SIB 51 05 20 FUEL FILLER DOOR STICKING

This Service Information Bulletin (Revision 1) replaces SI B51 05 20 **dated February 2020**.

E-Series	Model Description
G06	X6 Sports Activity Coupe
G07	X7 Sports Activity Vehicle

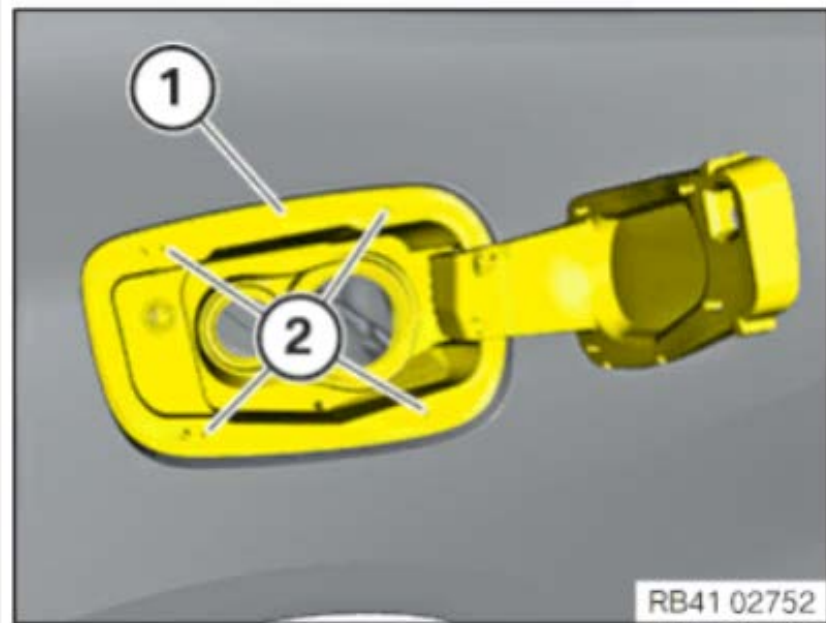
Press sealing cup (1) through to the outside.

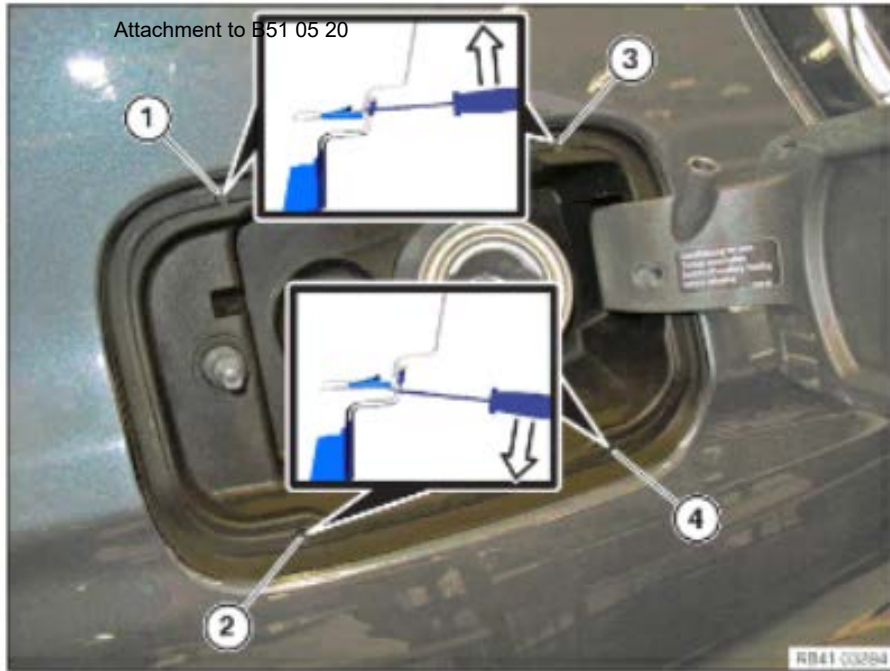
Pierce cover bowl at markings (3) with a small screwdriver.

Keep cover bowl tensioned.

Unlock catches individually with screwdriver

Unlock catches in following order:

- 1.Top left
- 2.Bottom left
- 3.Top right
- 4.Bottom right

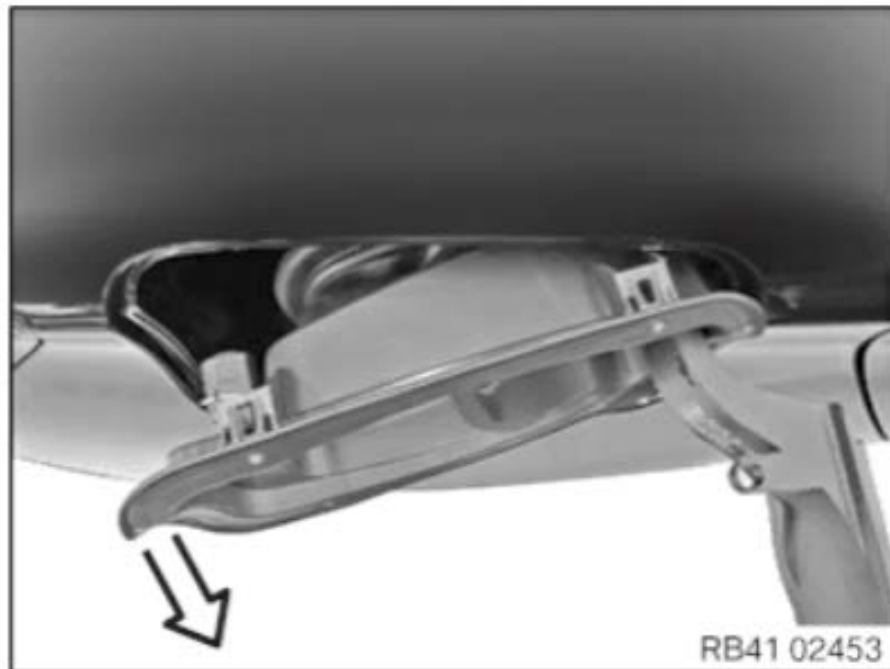
Move screwdriver in opposite direction at both lower catches.

Close the hinge arm.

Do not damage sheet metal flange of side wall.

Carefully twist out cover bowl at first at rear in direction of arrow from side wall and remove.
